Relevant Information for Local Planning Panel

FILE: D/2019/1163 **DATE:** 25 November 2020

SUBJECT: Information Relevant To Item 3 – Development Application: 51 Buckingham Street, Surry Hills – D/2019/1163

Figure 1: View from living room at 72/156 Chalmers Street, Surry Hills, looking north-west

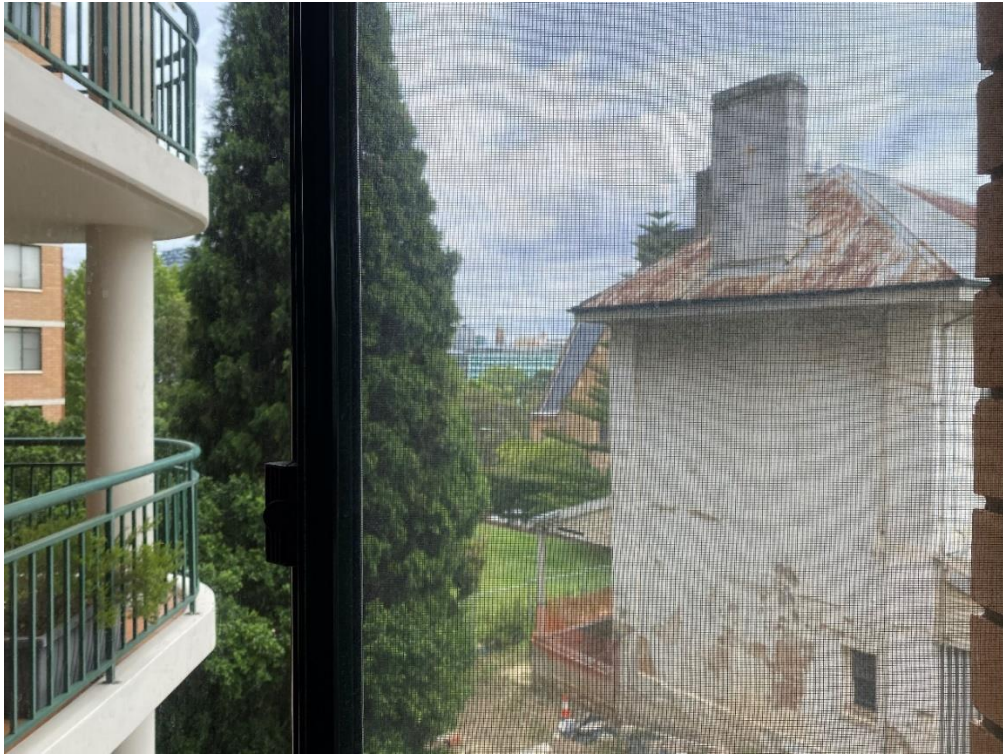
The submission raised concern about views obtained from a balcony and living room. During the site inspection it was observed that views are also obtained from a north-facing bedroom.

It is noted that the impact on views from living areas is more significant from bedrooms or service areas.
